MAINE TURNPIKE AUTHORITY ADMINISTRATION BUILDING

Re: Maine Turnpike Authority – Site Plan Review Application
Portland, Maine
SMRT Project No. 06016

**RE: Maine Turnpike Authority Headquarters Office Building
2360 Congress Street, Portland
Site Plan Application ID #2006-0090
CBL #233-A004-001 and #233-A008-001**

**MAINE TURNPIKE AUTHORITY HEADQUARTERS BUILDING
VICINITY OF 2360 CONGRESS STREET
SITE PLAN REVIEW
MAINE TURNPIKE AUTHORITY, APPLICANT**

MAINE TURNPIKE AUTHORITY
REVISED PARKING SPACES
SWIFT, INC.

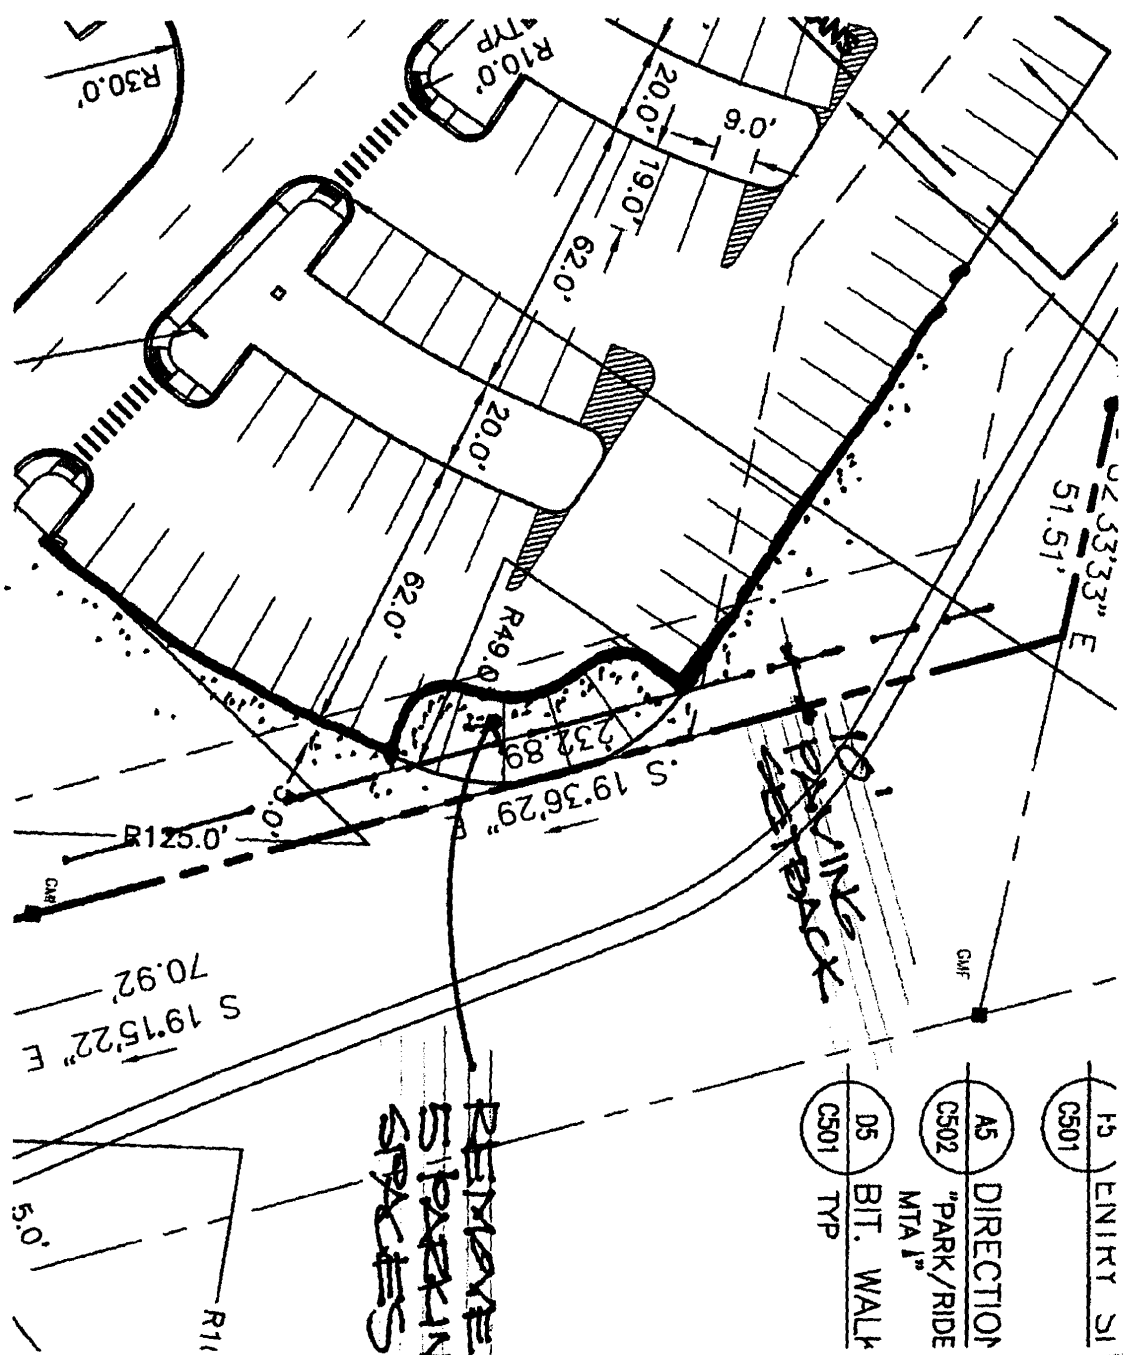
It is also noted that the I-M zone requires a minimum 10' pavement setback from lot boundaries. The pavement in one area goes directly up to the property line and is in violation.

At the beginning of the design process, it was believed that the Portland Water District easement on the northeast side of the property adjacent to the Connector road continued along the easterly edge of the lot. The final boundary research, completed just recently, revealed this not to be the case, and the plans were not adjusted accordingly. The plans are being revised, subtracting five (5) parking spaces nearest the property line, and allowing the 10-foot pavement setback. We will submit them shortly, prior to the first Workshop, and request that the review process proceeds on that basis. Please see the attached sketch outlining where the change will occur.

pavement setbacks
will change

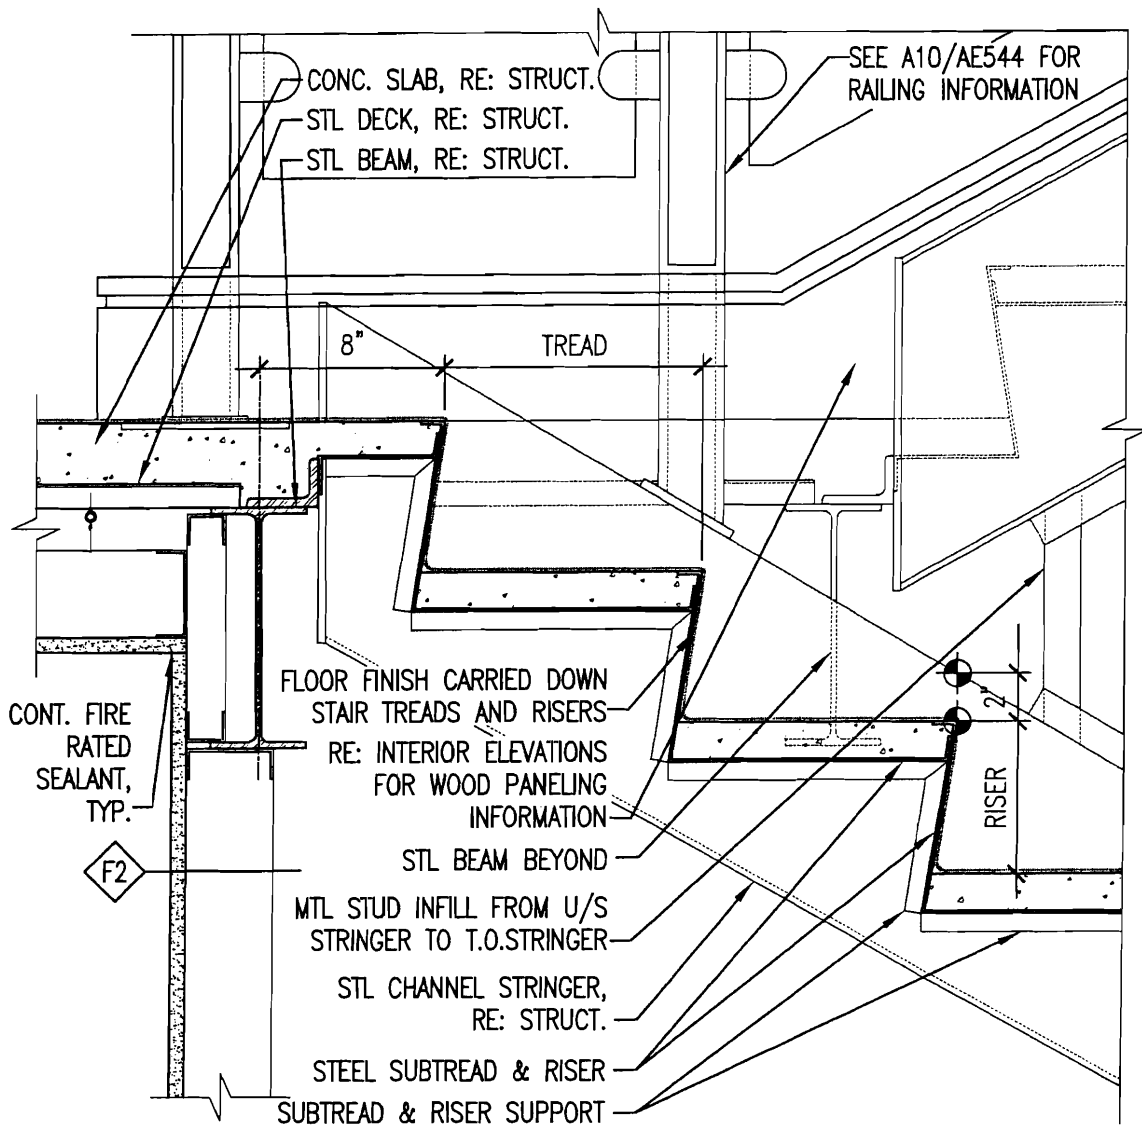
7. AE541 – STAIR SECTIONS & DETAILS:
a. A1/AE541: Revise detail reference E4/AE543 to J4/AE543.
8. AE543 – STAIR DETAILS:
a. Add details A4/AE543 – “Section Detail @ Stair Landing” and E1/AE543 – “Section Detail @ Top of Stair” included herein as Sketches No. A-1 and A-2.
